LAKEVIEW JSP 18-16

Public hearing at the request of Robertson Brothers Homes for Planning Commission's approval of the Preliminary Site Plan with Site Condominium, Wetland Permit, Woodland Permit, and Stormwater Management Plan. The subject property is zoned RM-2 with a Planned Rezoning Overlay (PRO), which conditions development to the terms of a PRO Plan and Agreement. The subject property is approximately 3.15 acres and is located south of 13 Mile Road on the east and west sides of Old Novi Road (Section 10 and 11). The applicant is proposing the development of 20 single-family detached site condominiums and stormwater management facilities.

PLAN REVIEW CENTER REPORT

Preliminary Site Plan

Typical Old Novi Rd. Frontage Detail

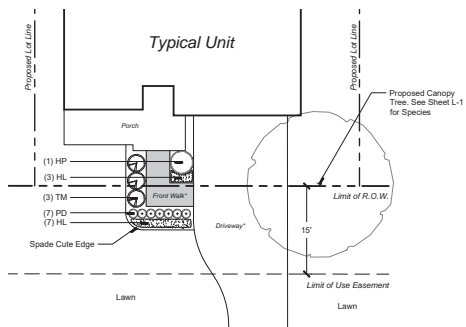
1. **Sidewalk:** The applicant and city staff have agreed to a realignment of the portion of sidewalk on the east side of Old Novi Road, north of Wainwright Street in order to improve the safety of pedestrians and bicyclists. **The applicant should show the new alignment in the Final Site Plan submittal. The 6-foot sidewalk should be located outside of the 25-foot vegetated buffer of the stormwater management plan. The landscaping plan will also require adjustments to accommodate the realignment of the sidewalk.**

6' ht. Screen Fence Detail

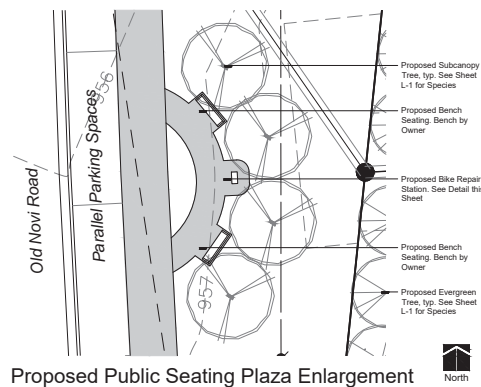
4. **Fences:** The PRO Agreement (G.3.i) states that "A 6-foot tall fence, as shown on the detail provided on Sheet L5 (or an approved comparable fence as determined by the City's Landscape Architect), shall be required between the new lots/units and all adjacent residential lots." The site plan does not indicate a fence along the side yards of lots 14, 15 or 20, which are adjacent to residential lots. Fencing is also required as alternative screening north of the stormwater detention basin, as shown on sheet L-1 and in detail on sheet L-5. **The applicant shall update sheets SP2, SP6, and SP7 to indicate fence installation at those locations.**
